Contract #: 04-0120F4
 Cty: SF/ALA Rte: 80 PM: 13.2/13.9
 File #: 69.25B

QUALITY ASSURANCE -- NON-CONFORMANCE REPORT

Report No: NCR-000847

Job Name: SAS Superstructure
Document No: 05.03.06-000805

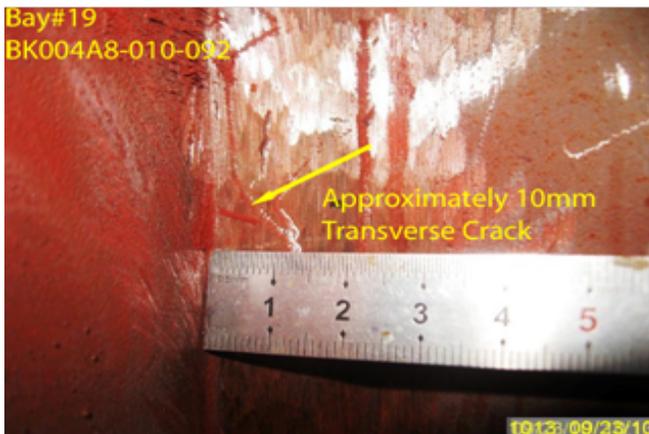
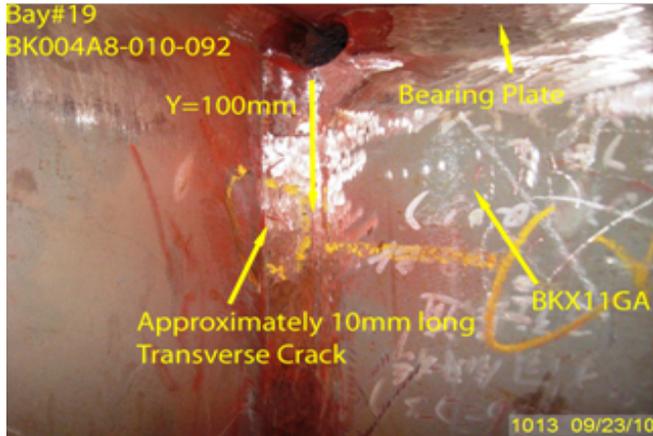
During the Quality Assurance (QA) Magnetic particle Testing (MT) review of welds located on OBG Bike path BK004A-010, this QA Inspector discovered the following issue:

- One transverse crack that measured approximately 10mm in length.
- The weld is identified as BK004A8-010-092.
- The weld is a Partial joint penetration (PJP) T joint, joining the Stringer plate (BKX9C) to the End diaphragm plate (BKX11GA).
- The Y Location is 100mm from the bearing plate.
- The OBG Bike path is located in BAY#19.
- This crack is clearly marked on the material on/near the weld.
- This weld joint is designated as Non-Seismic performance critical (Non-SPCM) weld member.
- The Notice of Witness Inspection Number (NWIT) is 006731.
- The crack is located within the area that has been re-tested and accepted by ZPMC Quality Control (QC) subsequent to the heat straightening procedure.

AWS D1.5 (02) Section 6.26.2 – “Welds that are subject to MT in addition to visual inspection shall have no cracks.

ZPMC acknowledged the indication was missed and has issued an internal NCR to address this problem. ZPMC has repaired the indication and is providing the NDT record to show the acceptance of this weld. Based on this, ZPMC is requesting closure of this NCR.

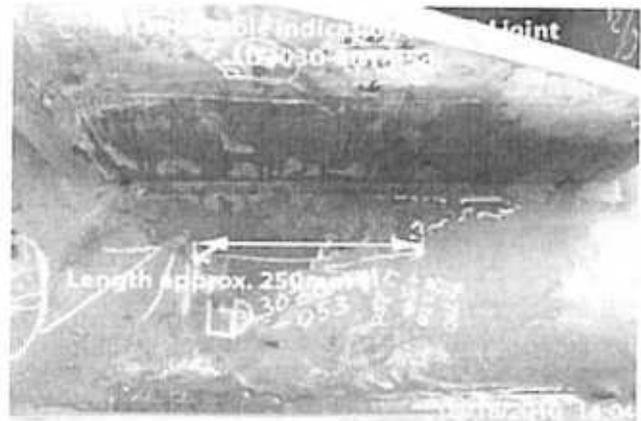
During the Quality Assurance (QA) Ultrasonic Testing (UT) review of welds located on Orthotropic Box Girder (OBG) segment 13BE and 13CE, this QA Inspector discovered the following issues:

- Three (3) longitudinal linear class "A" rejectable indications measuring approximately 180mm~260mm in length.
- The welds are identified as LD3028-001-031, LD3027-001-026 and LD3030-001-053.

AWS D1.5-02 Section 6; Table 6.3 specifies a class "A" indication as having a rating of 8d and under for material thicknesses 21mm through 38mm.

These welds were designated to be PJP welds and no UT is required. The NWIT were submitted due to the internal fault between the floor QC & NDT operator of ZPMC. ZPMC is providing the MT records to show the acceptance of these welds and is requesting closure of this NCR.

LONGITUDINAL DIAPHRAGM SUB-ASSY ~ MARK LD3028A
(TYPE 2) (⊕ E3, LOOKING NORTH - DEVELOPED)

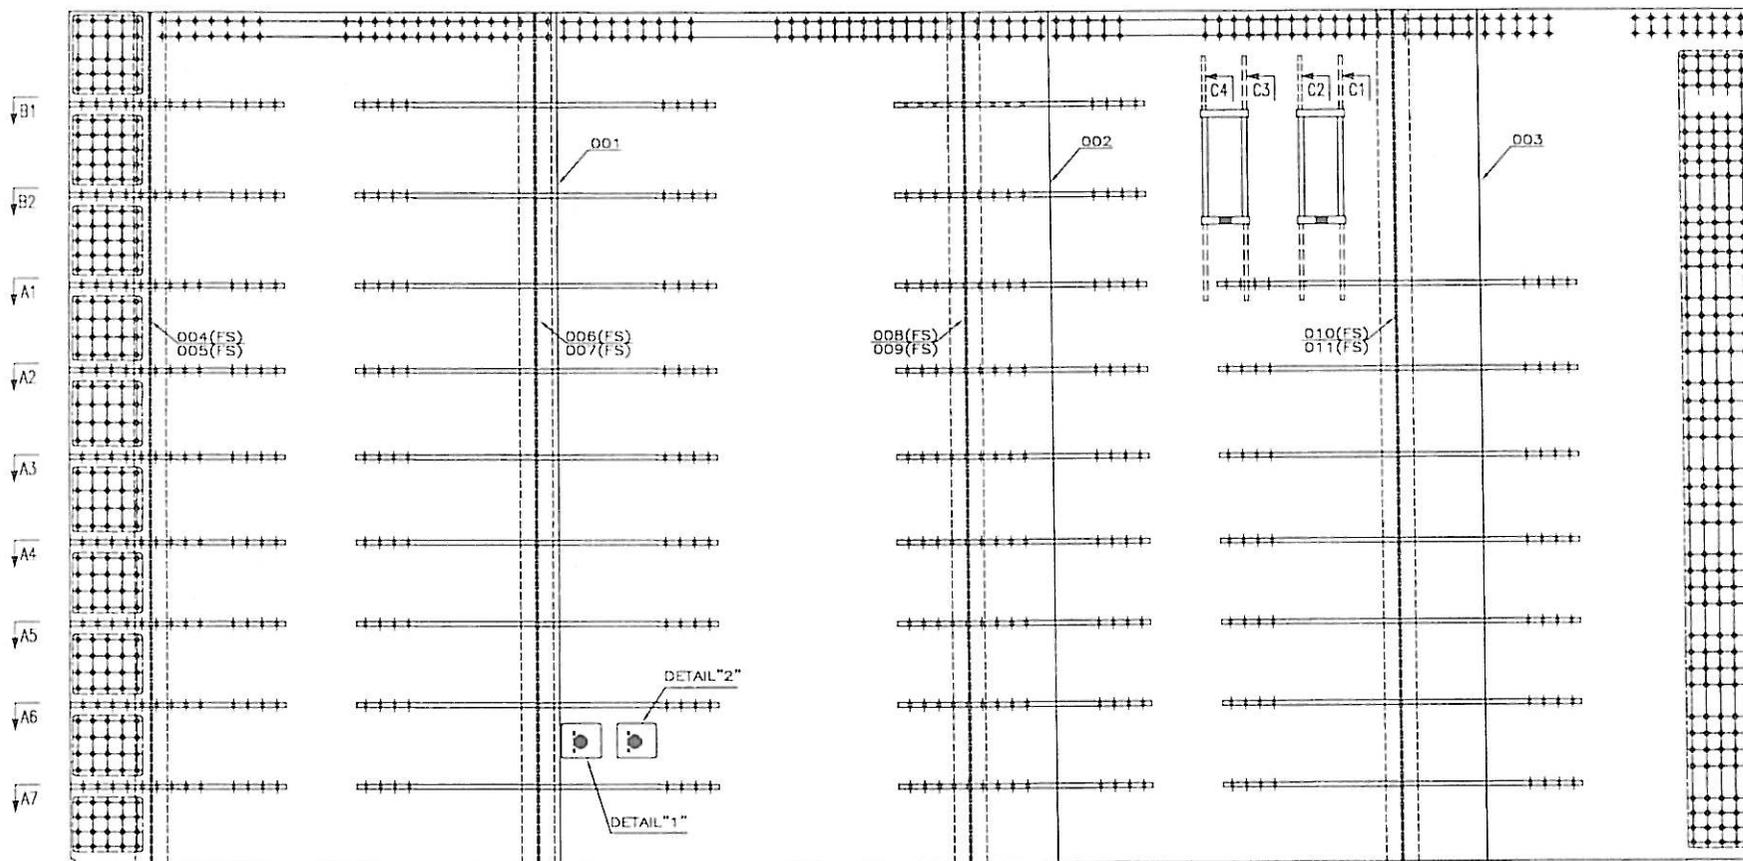
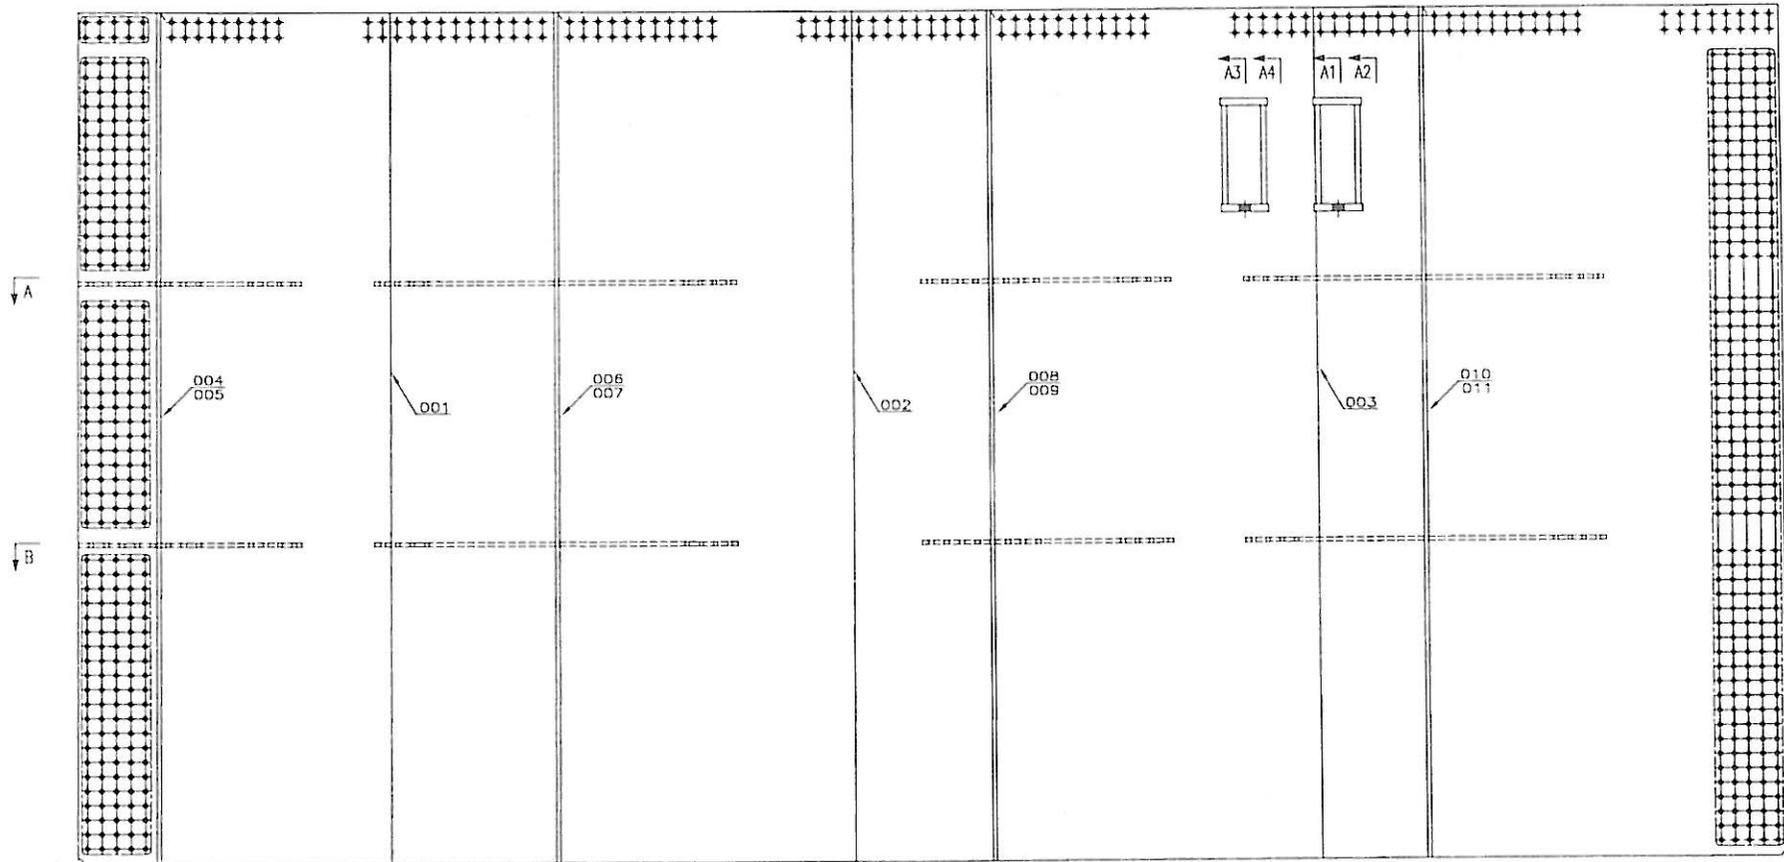
- The indication db rating for joint LD3030-001-053 is a +5.
- The depth of the indications are from 20mm~23mm deep.
- The Weld LD3028-001-031 is joining longitudinal diaphragm (X3682A) to lifting Lug.

LONGITUDINAL DIAPHRAGM SUB-ASSY ~ MARK LD3030A
(TYPE 2) (Ø E3, LOOKING NORTH - DEVELOPED)

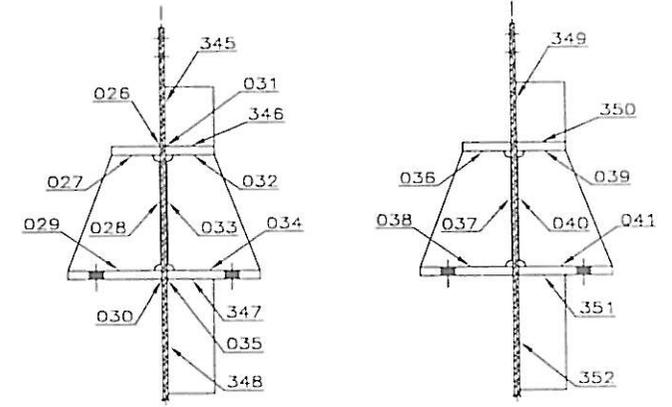
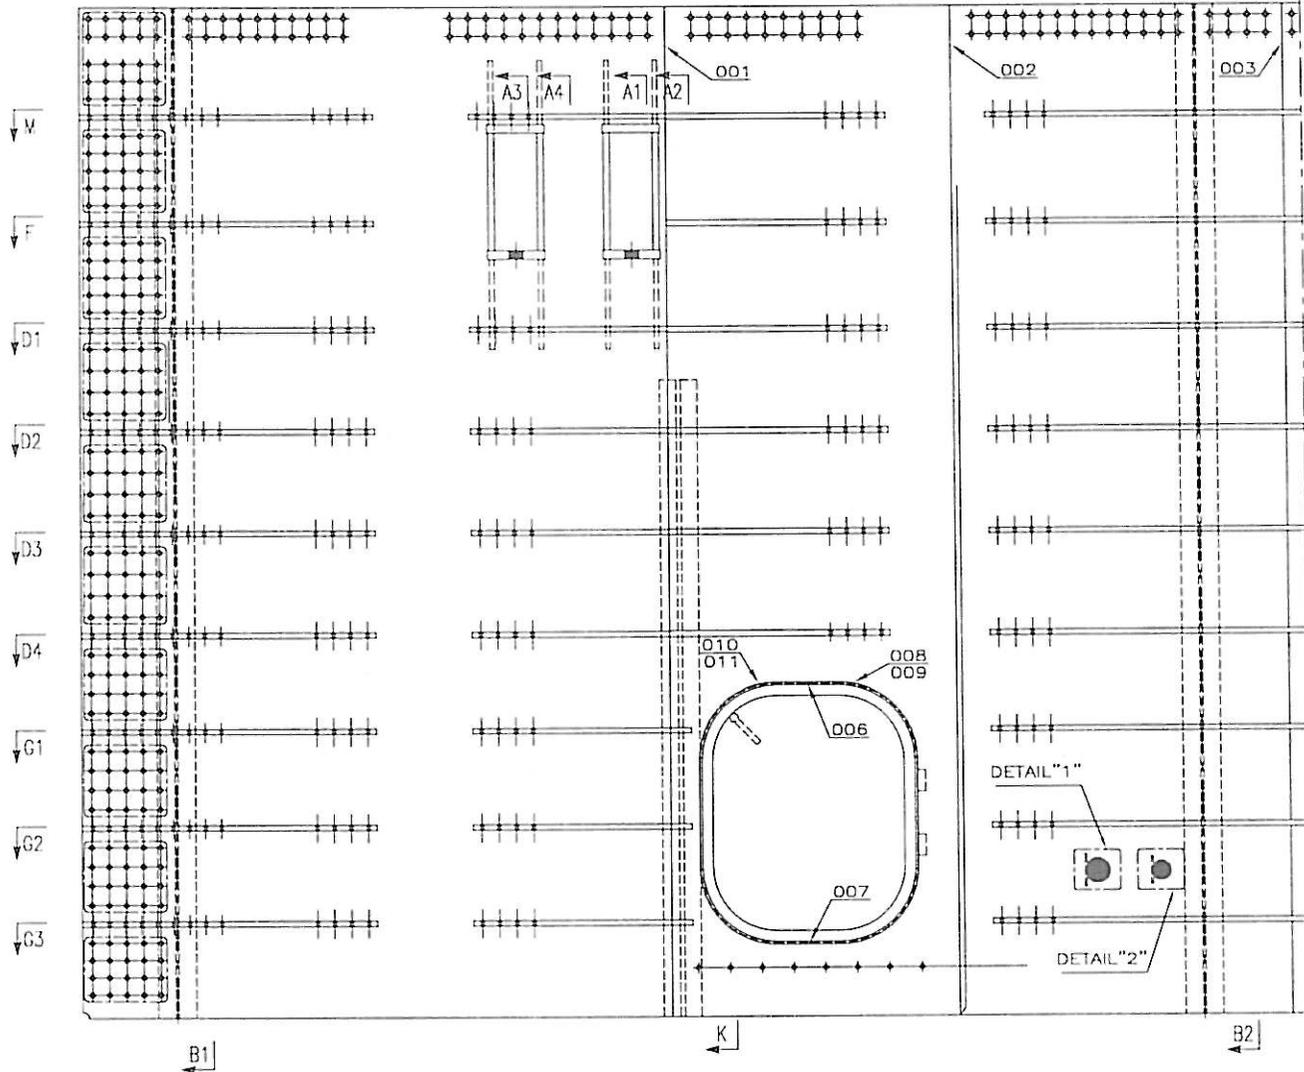
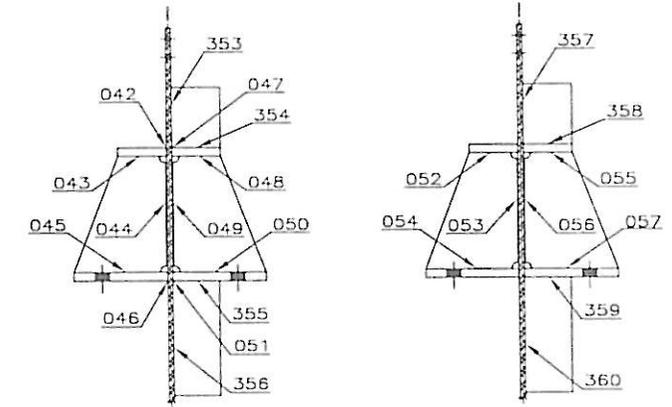
- The Weld LD3027-001-026 is joining longitudinal diaphragm (X3684B) to lifting Lug.
- The Weld LD3030-001-053 is joining longitudinal diaphragm (X3685A) to lifting Lug.

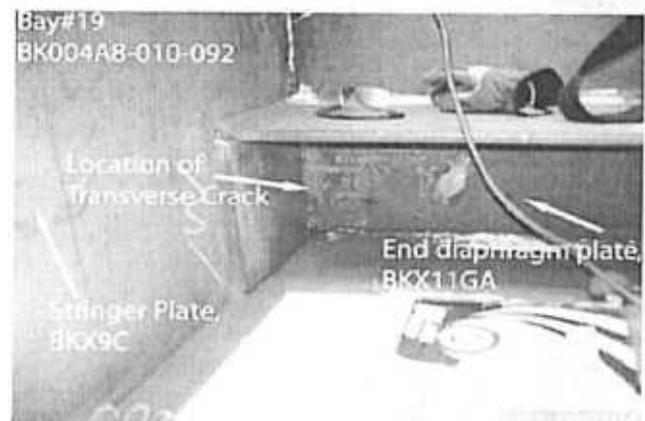
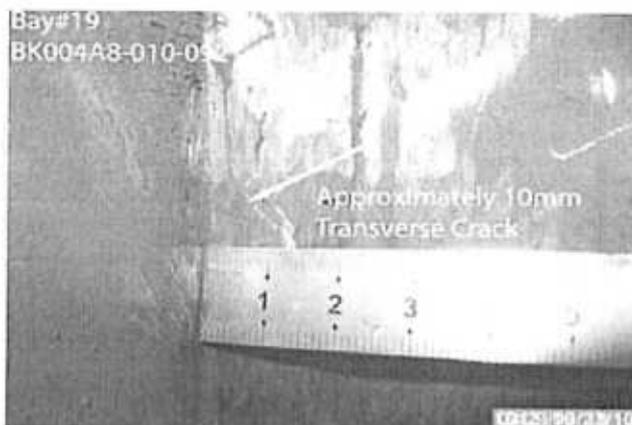
During the Quality Assurance (QA) Magnetic particle Testing (MT) review of welds located on OBG Bike path BK004A-010, this QA Inspector discovered the following issue:

- One transverse crack that measured approximately 10mm in length.
- The weld is identified as BK004A8-010-092.
- The weld is a Partial joint penetration (PJP) T joint, joining the Stringer plate (BKX9C) to the End diaphragm plate (BKX11GA).
- The Y Location is 100mm from the bearing plate.
- The OBG Bike path is located in BAY#19.
- This crack is clearly marked on the material on/near the weld.
- This weld joint is designated as Non-Seismic performance critical (Non-SPCM) weld member.
- The Notice of Witness Inspection Number (NWIT) is 006731.
- The crack is located within the area that has been re-tested and accepted by ZPMC Quality Control (QC) subsequent to the heat straightening procedure.

AWS D1.5 (02) Section 6.26.2 – "Welds that are subject to MT in addition to visual inspection shall have no cracks."

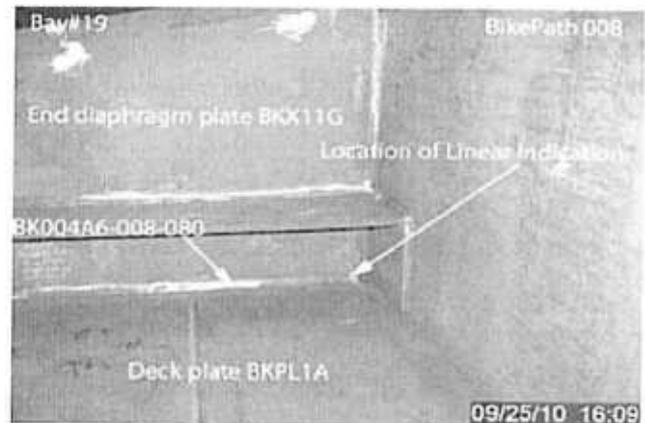
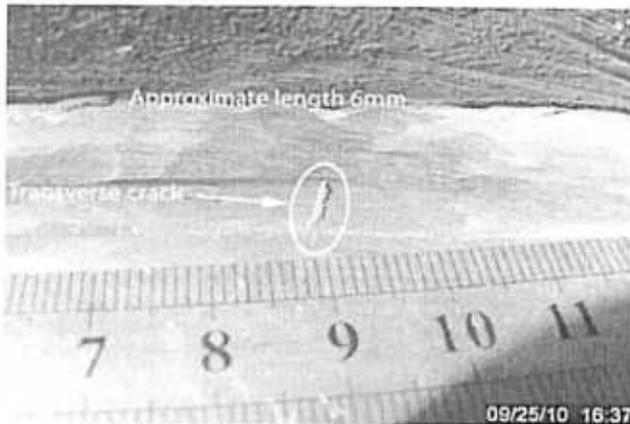
During the Quality Assurance (QA) Magnetic Particle Testing (MT) review of welds located on Bike Path 008, this QA Inspector discovered the following issues:

- One Longitudinal linear crack in the weld measuring approximately 15mm in length.
- The weld is identified as BK004A6-008-080.
- The weld is partial joint penetration (PJP), joining the End Diaphragm plate identified as BKX11G to the Deck Plate identified as BKPL1A.
- This weld joint is designated as Non-Seismic performance critical (Non-SPCM) weld member.
- The crack is clearly marked on the material near the weld.
- The OBG Bike Path 008 is located in Bay #19.

Quality Assurance (QA) Magnetic Particle Testing (MT) review of fillet welds located on OBG bike path BK004A-018, this QA Inspector discovered the following issues:

- One (1) transverse crack found on the weld measuring approximately 6mm in length.
- Y location of the indication is measured to be 2160mm.
- The crack is clearly marked on the weld joint.
- The weld is identified as: BK004A3-018-052.
- The Weld is a fillet weld joining the stringer plate (8C) to the deck plate of bike path.
- The member is located in bay 11.

ZPMC acknowledged the indications were missed and has issued an internal NCR to address this problem. ZPMC has repaired the indications and is providing the NDT records to show the acceptance of the welds. Based on this, ZPMC is requesting closure of this NCR.

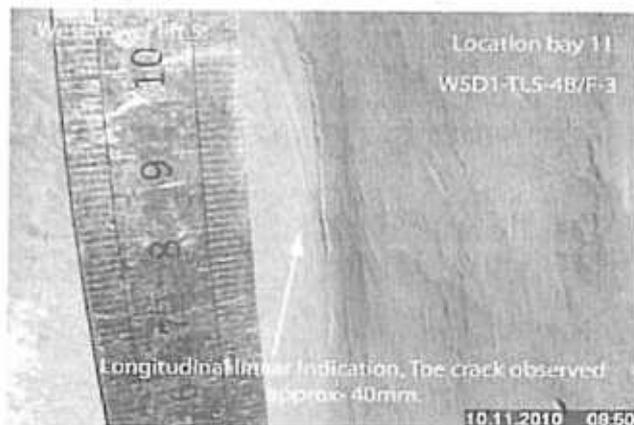
During the Quality Assurance (QA) Magnetic Particle Testing (MT) review of welds located in West Tower lift 5 Grillage plate, WSD1-TL5-4B/F-3, this Quality Assurance (QA) Inspector discovered the following issues:

-One longitudinal toe crack measuring approximately 40mm in length.

-The weld is identified as: WSD1-TL5-4B/F-3.

-The Notice of Witness Inspection Number (NWIT) is 06917. The indication is located on CJP weld area that has been previously tested and accepted by ZPMC Quality Control (QC) personnel. As per the contract documents, ZPMC's QC personnel are required to perform 100% MT inspection of this weld. The attached photographs provide additional detail.

ZPMC acknowledged the indication was missed and has issued an internal NCR to address this problem. ZPMC has repaired the indication and is providing the NDT record to show the acceptance of this weld. Based on this, ZPMC is requesting closure of this NCR.

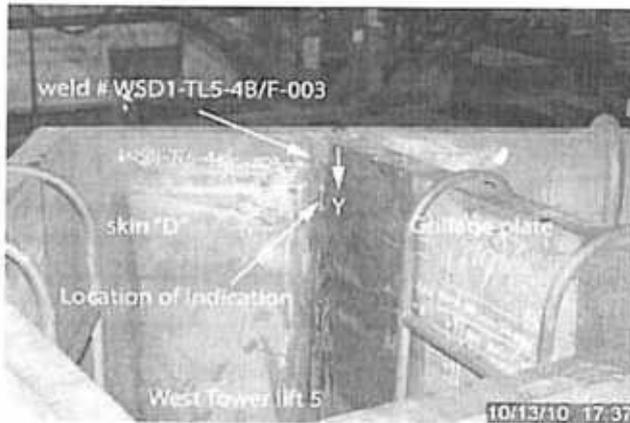
During the Quality Assurance Ultrasonic Testing (UT) verification of welds located on grillage plate of West Tower lift 5, this Quality Assurance (QA) Inspector discovered the following issues:

- One class "A" longitudinal indication measuring approximately 50mm in length.
- The depth of the indication is 57mm.
- The db rating is -2.
- The material thickness is 65mm.
- The weld is identified as: WSD1-TL5-4B/F-003.
- The Weld is a Complete Joint Penetration (CJP) with steel backing, T-joint, joining the grillage plate to the skin plate (skin "D").
- The "Y" location of the indication is 110mm from top side
- The indication is clearly marked on the component.
- The member is located in Bay 11.

The Notice of Witness Inspection Number (NWIT) is 06938. The indication is located inside the area that has been previously tested and accepted by ZPMC Quality Control (QC) personnel. As per the contract documents, ZPMC's QC personnel are required to perform 100% UT inspection of this weld.

-Attached photographs provide additional location details.

ZPMC acknowledged the indication was missed and has issued an internal NCR to address this problem. ZPMC has repaired the indication and is providing the NDT record to show the acceptance of this weld. Based on this, ZPMC is requesting closure of this NCR.

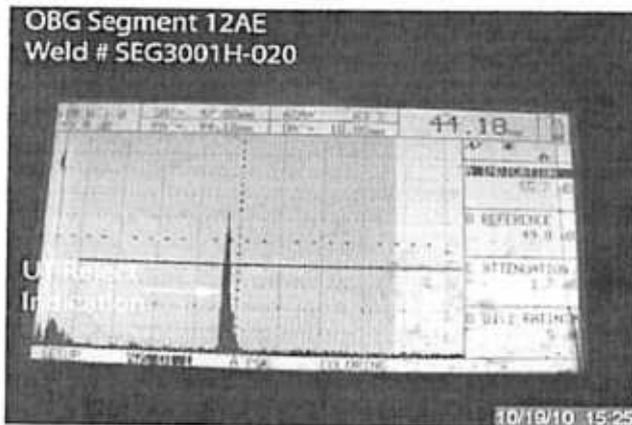
During the Quality Assurance (QA) Ultrasonic Testing (UT) verification of weld located on Segment 12AE, this QA Inspector discovered the following issue:

Contractor proposes to repair the weld indication, and provide NDT report to prove the weld is acceptable. Contractor will monitor the inspector who missed the indication, and take disciplinary action should be continuously making similar mistakes.
